TITEL: Kontroll av oljefilteradaptorns montering

ÅTGÄRD: Enligt bifogad kopia av FAA AD 96-12-22

96-12-22 CESSNA AIRCRAFT COMPANY: Amendment 39-9665; Docket No. 93-CE-54-AD.

Figure 1 Oil Filter Adapter Installation
AD 96-12-22

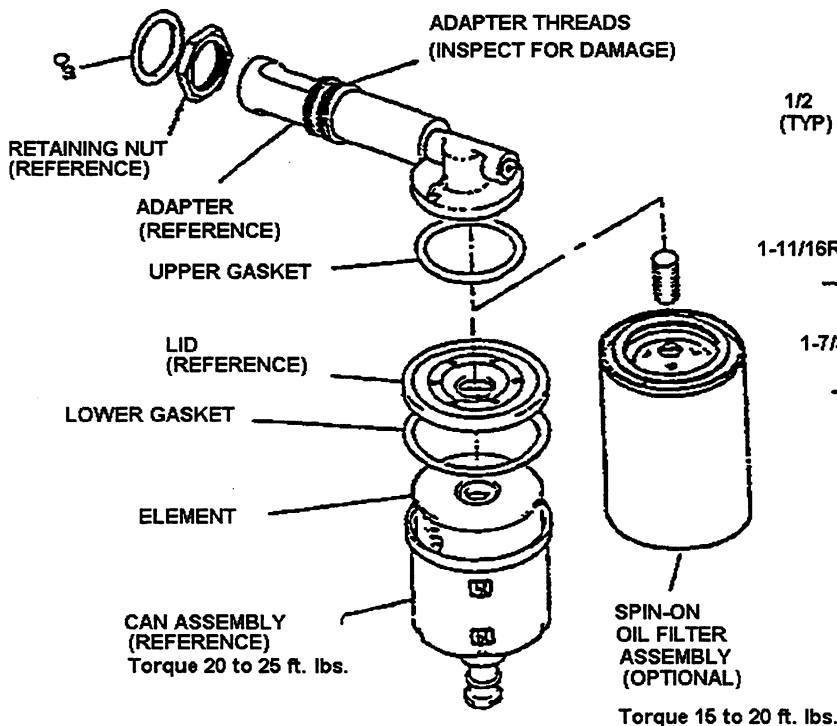
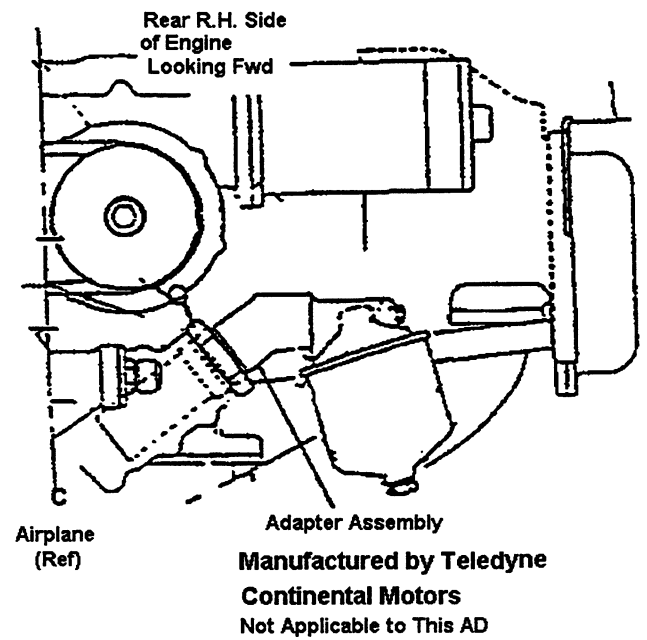
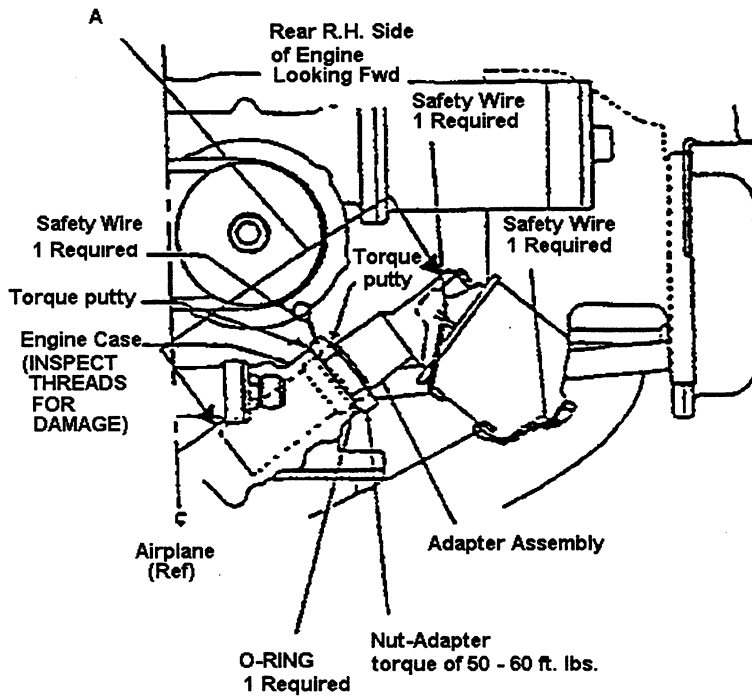
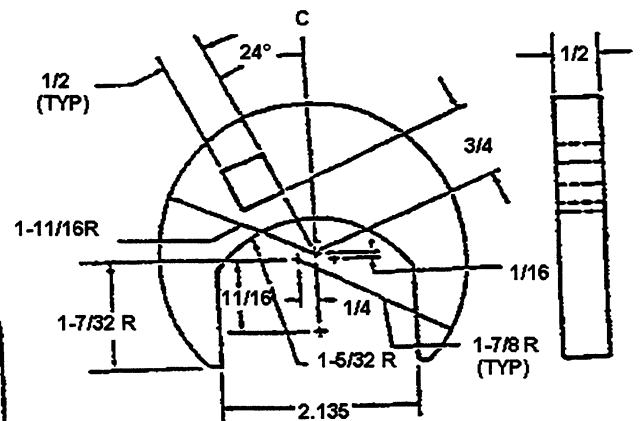
NOTE 2: This AD does not apply to engine oil filter adapter assemblies manufactured by Teledyne Continental Motors (See Figure 1 of this AD).

- (1) Inspect the adapter locking nut installation for evidence of oil leakage.
- (2) Check the torque of the adapter nut installation and ensure that the torque value is within the limits of 50 through 60 foot pounds.
- (3) If evidence of oil leakage is found or the torque is not within the 50 through 60-foot pound limit, prior to further flight, remove the adapter and filter assembly, and:
 - (i) Inspect the threads of the adapter assembly and engine for signs of damaged or cracked threads; and
 - (ii) Replace any adapter assembly and engine oil pump housing (if necessary) that have evidence of thread damage or cracks.
- (4) Apply torque putty between the engine filter adapter assembly, nut, and oil pump housing as specified in Figure 1 of this AD.
- (5) Reassemble the engine oil filter assembly.

TOOL NUMBER SE709 IS AVAILABLE FROM THE CESSNA SERVICE PARTS CENTER

Snap-On crows foot P/N AN8508-34A
have ground down the ends for clearance
